ATTACHMENT B

PROPOSED CHANGES TO APPENDIX A, TECHNICAL SPECIFICATIONS  
OF FACILITY OPERATING LICENSE DPR-19

DPR-19

FIGURE 3.6.1.

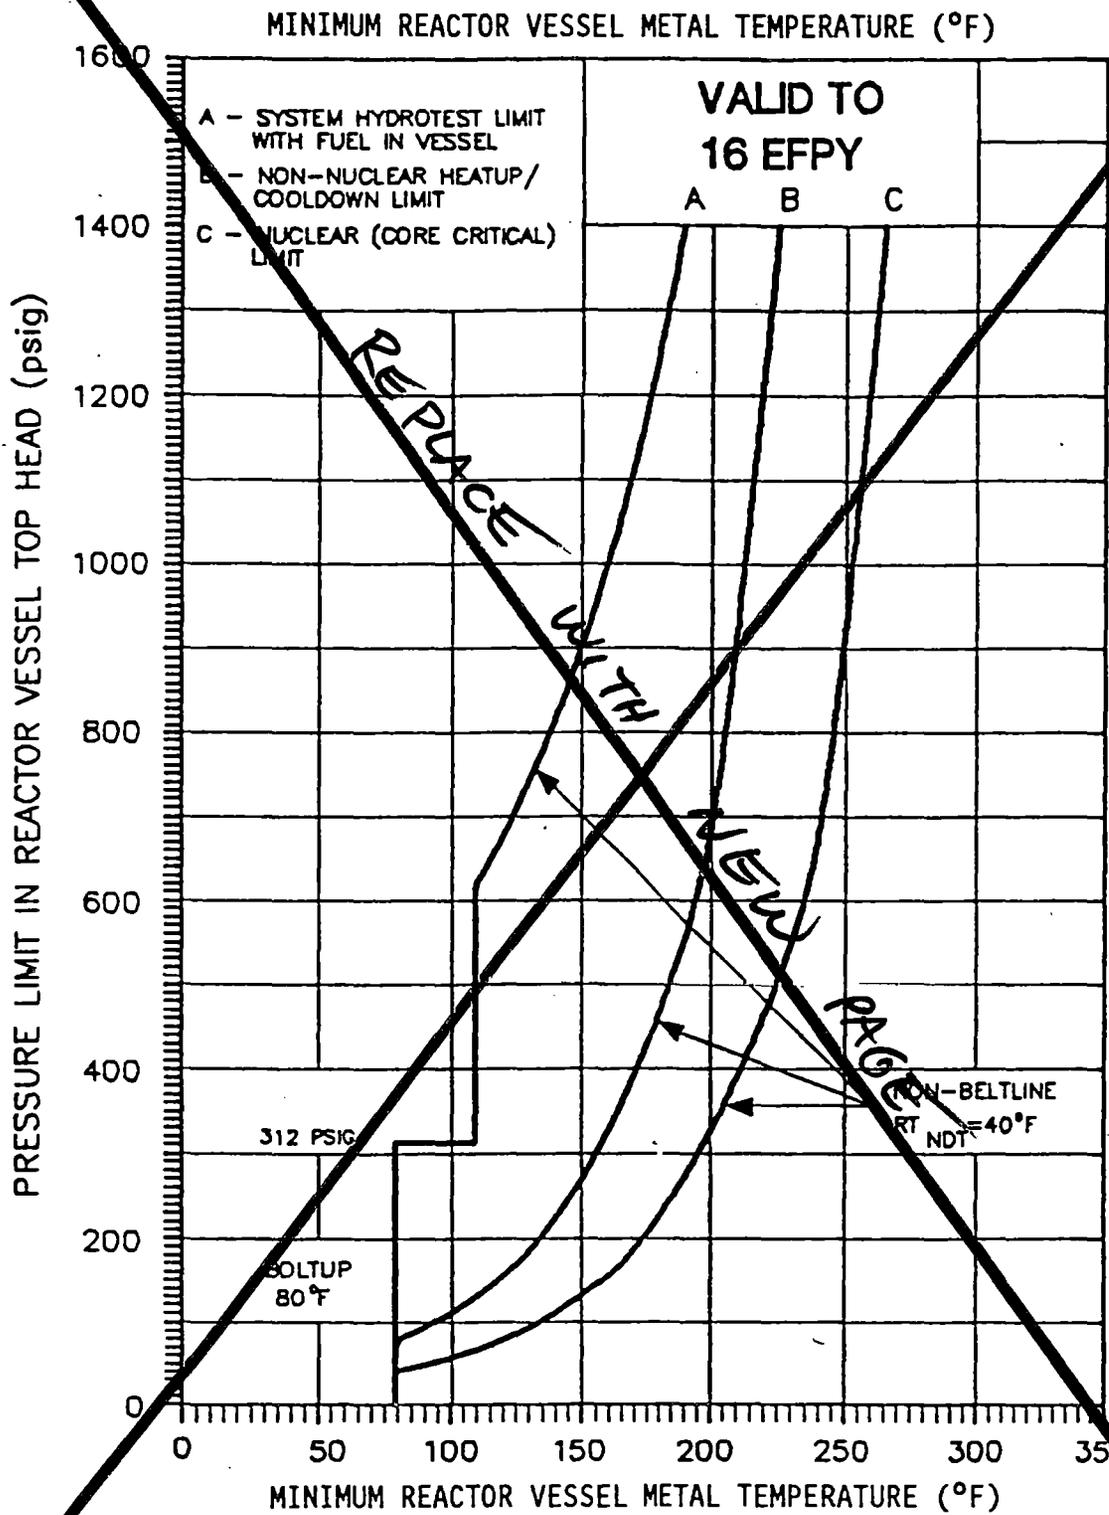
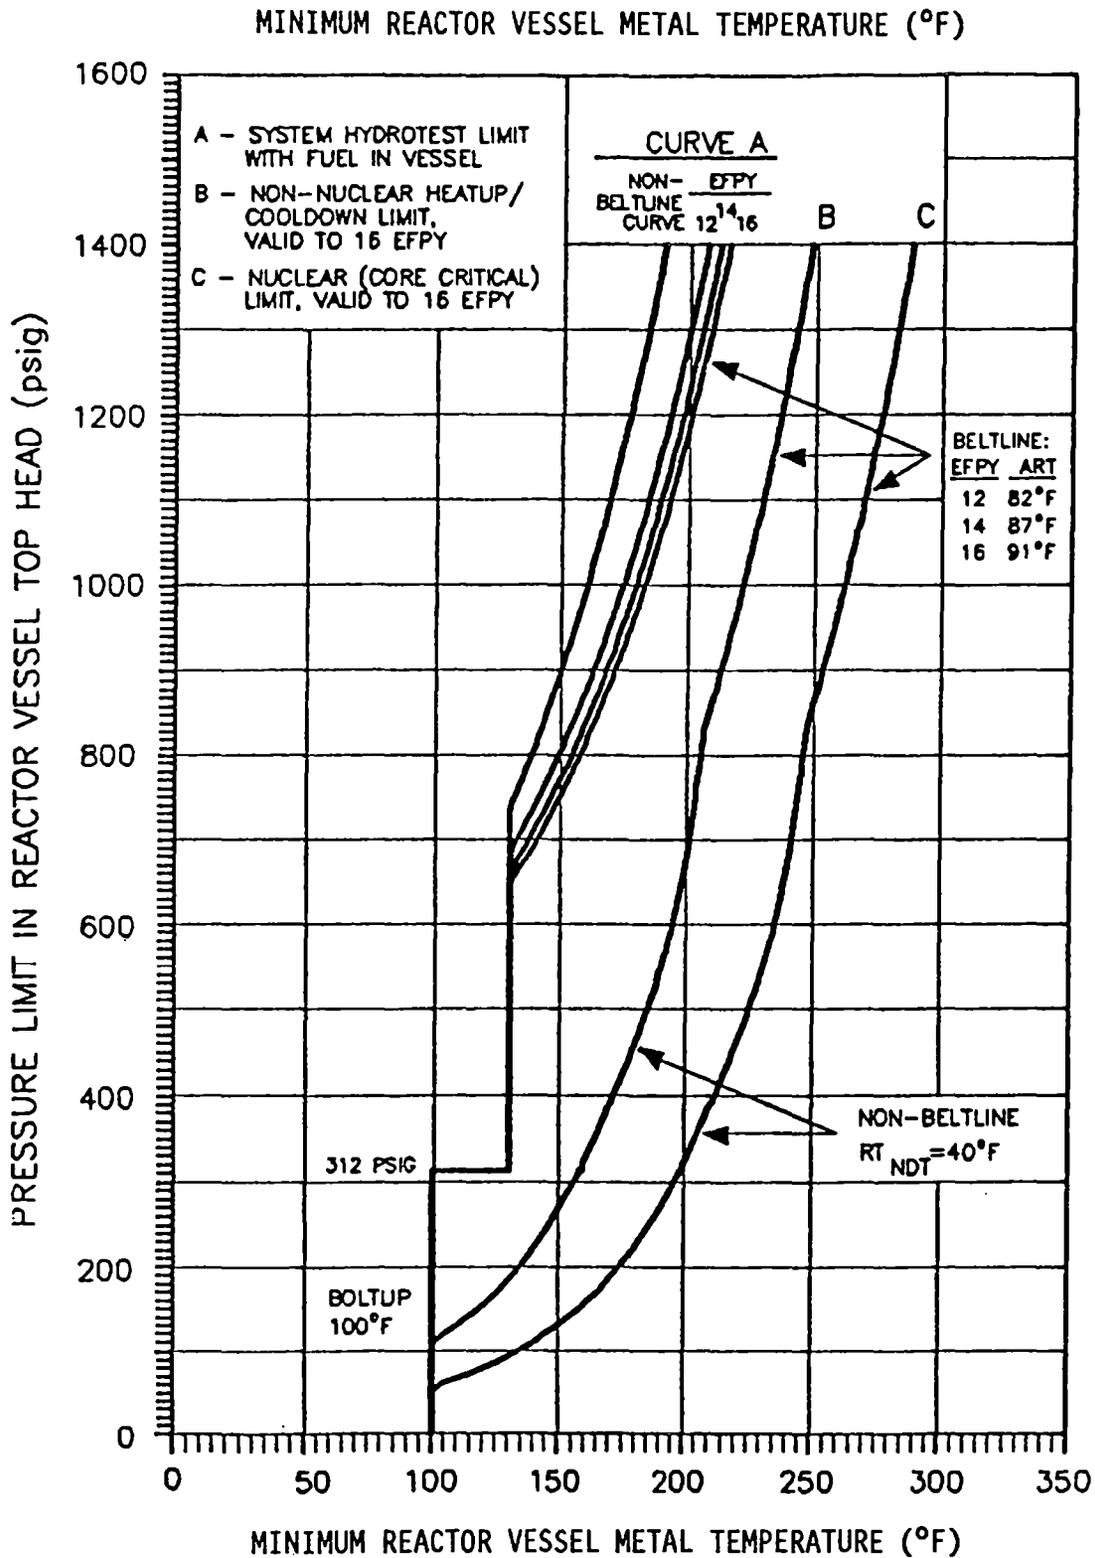
As indicated in Curve A of Figure 3.6-1 for system hydratesting, the minimum metal temperature of the reactor vessel shell is 80°F for reactor pressures less than 312 psig. This 80°F minimum boltup temperature is based on an RT<sub>NDT</sub> of 20°F for the top head plate (most limiting material) and a 60°F conservatism required by the original ASME Code of construction.

At reactor pressures greater than 312 psig, the minimum vessel metal temperature is established as 110°F. The 110°F minimum temperature is based on a closure flange region RT<sub>NDT</sub> of 20°F and a 90°F conservatism required by 10 CFR 50 Appendix G for pressure in excess of 20% of the preservice hydrostatic test pressure (1563 psig).

At approximately 620 psig reactor pressure the effects of pressurization become more limiting than the boltup stresses at the closure flange region, as shown by the non-linear portion of Curve A intersecting the vertical 110°F line. The non-linear portion of the curve is dependent on the non-beltline region (which is actually more limiting than the beltline region through a vessel exposure of 22 effective full power years), and based on an RT<sub>NDT</sub> of 40°F.

Curve B of Figure 3.6.1 applies during heatups with non-nuclear heat (e.g., recirculation pump heat) and during cooldowns when the reactor is not critical (e.g., following a scram). The curve provides the minimum reactor vessel metal temperatures based on the most limiting vessel stress (non-beltline stresses).

As indicated by the vertical 80°F line, the boltup stresses at the closure flange region are most limiting below approximately 80 psig. Above approximately 80 psig, pressurization and thermal stresses become more limiting than the boltup stresses, which is reflected by the non-linear portion of Curve B. The non-linear portion of the curve is dependent on non-beltline region (which is actually more limiting than the beltline region through a vessel exposure of 22 effective full power years), and based on an RT<sub>NDT</sub> of 40°F.

Curve C, the core critical operation curve shown in Figure 3.6.1, is generated in accordance with 10 CFR 50 Appendix G which requires core critical pressure-temperature limits to be 40°F above any Curve A or B limits. Since Curve B is more limiting, Curve C is Curve B plus 40°F.

At approximately 650 psig the effects of pressurization are more limiting than the boltup stresses at the closure flange region, hence a family of non-linear curves intersect the 130 °F vertical line. Belt-line as well as non-beltline curves have been provided to allow separate monitoring of the two regions. Beltline curves as a function of vessel exposure for 12, 14, and 16 effective full power years (EFPY) are presented to allow the use of the appropriate curve up to 16 EFPY of operation.

As indicated by the vertical 100 °F line, the boltup stresses at the closure flange region are most limiting for reactor pressures below approximately 110 psig. For reactor pressures greater than approximately 110 psig, pressurization and thermal stresses become more limiting than the boltup stresses, which is reflected by the non-linear portion of Curve B. The non-linear portion of the curve is dependent on non-beltline and beltline regions, with the beltline region temperature limits having been adjusted to account for vessel irradiation (up to a vessel exposure of 16 EFPY). The non-beltline region is limiting between approximately 110 psig and 830 psig. Above approximately 830 psig, the beltline region becomes limiting.
